**Re: Comments on Proposed OCS PSD Permit #R10OCS/PSD-AK-2010-01
Frontier Discoverer Drillship/Beaufort Sea Exploration Drilling Program**

**Comments on Proposed OCS PSD Permit No. R10OCS/PSD-AK-2010-01
Shell Offshore Inc.
Beaufort Sea Exploration Drilling Program**

Figure 1. Historical PM10 Data Collected at Badami

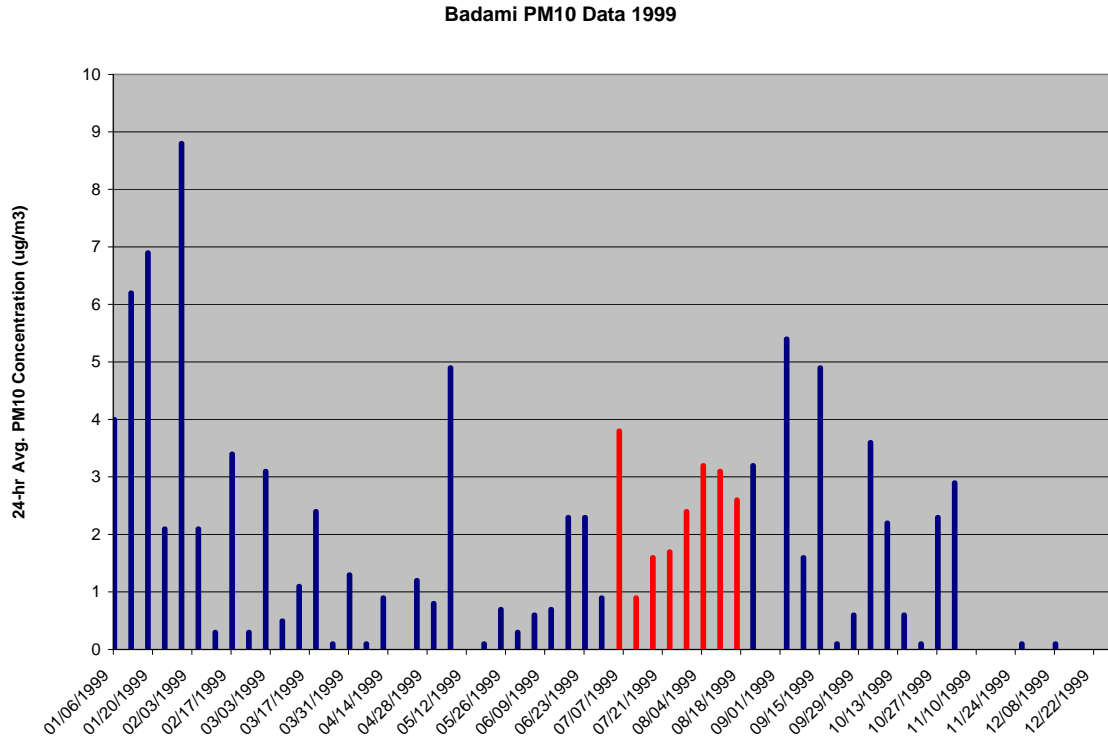
Examination of historical monitoring data for the Beaufort Sea coastal area reveals that the period from July through mid-August is not typically a high particulate concentration period. Figure 1 is a plot of 1999 historical PM₁₀ data collected at the Badami site. Data collected in the period from July 1 through August 19 has been highlighted in red. As the

data clearly show, the July 1 – August 19 period is not the highest concentration period during the year.

The conclusion is drawn that for the Beaufort Sea area, the July 1 – August 19 period would be expected to have lower concentrations than the period later in the fall. Thus the ambient monitoring that has been performed by Shell is reflective of peak particulate concentrations.

Figure 2. Historical PM10 Data Collected in Prudhoe Bay

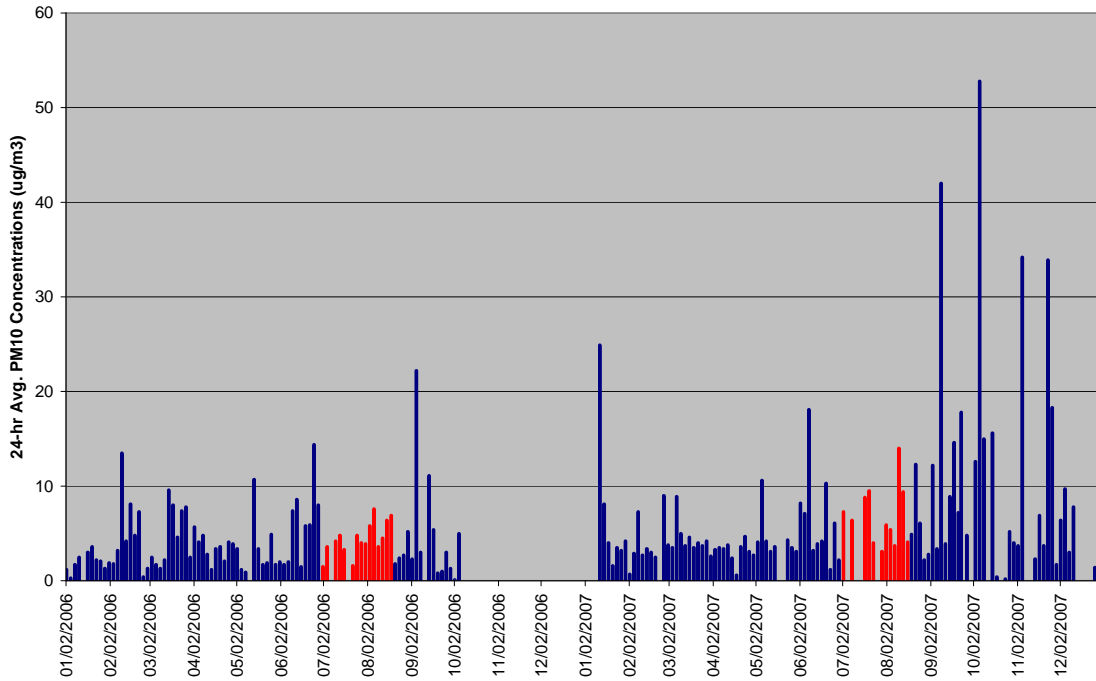
Similarly, data collected in 2006-2007 at the Central Compressor Plant in Prudhoe Bay by BP, shown in Figure 2, depict the same pattern. Again, the period in question has been highlighted in red. Consistent with the historical observations at Badami, the July 1 – August 19 period is definitely not representative of peak particulate concentrations.

Hull 247 Generator Specifications

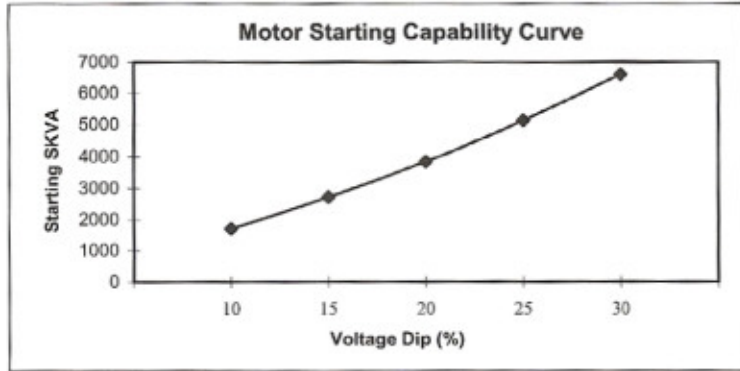
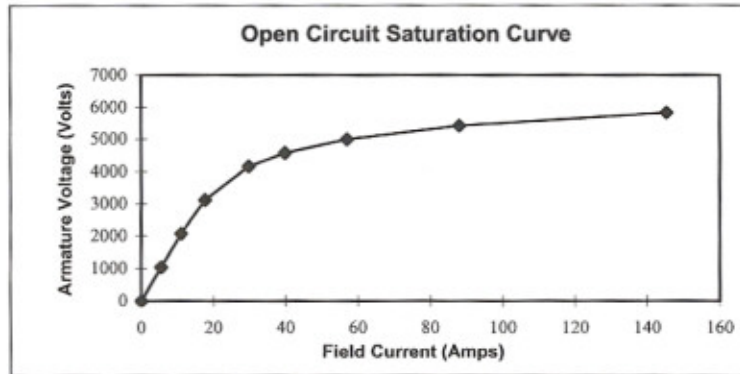
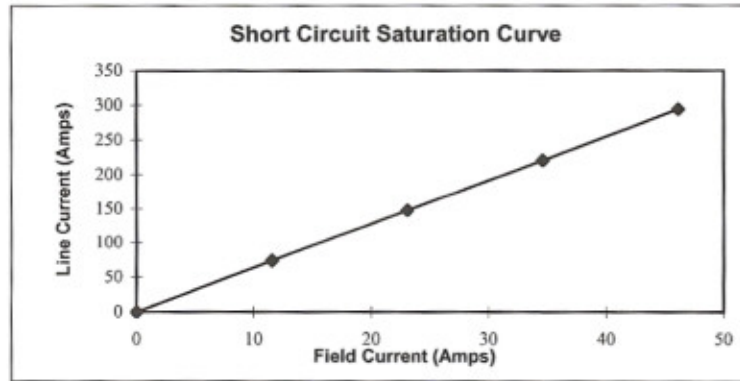
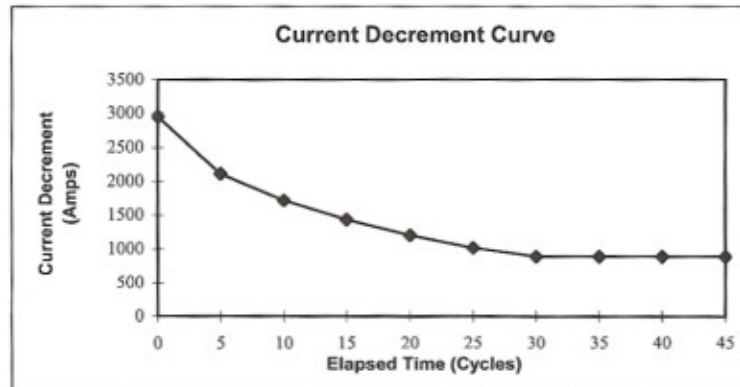
Proposed **Condition P.5** (page 76) assumes mechanical to electrical conversion efficiency of 92 percent for the generators on board Hull 247. As shown on Attachment A, however, these generators have mechanical to electrical conversion efficiency of 95 percent. Shell requests that this higher efficiency be used to calculate the energy production allowance in Conditions P.5.2 and P.5.4.
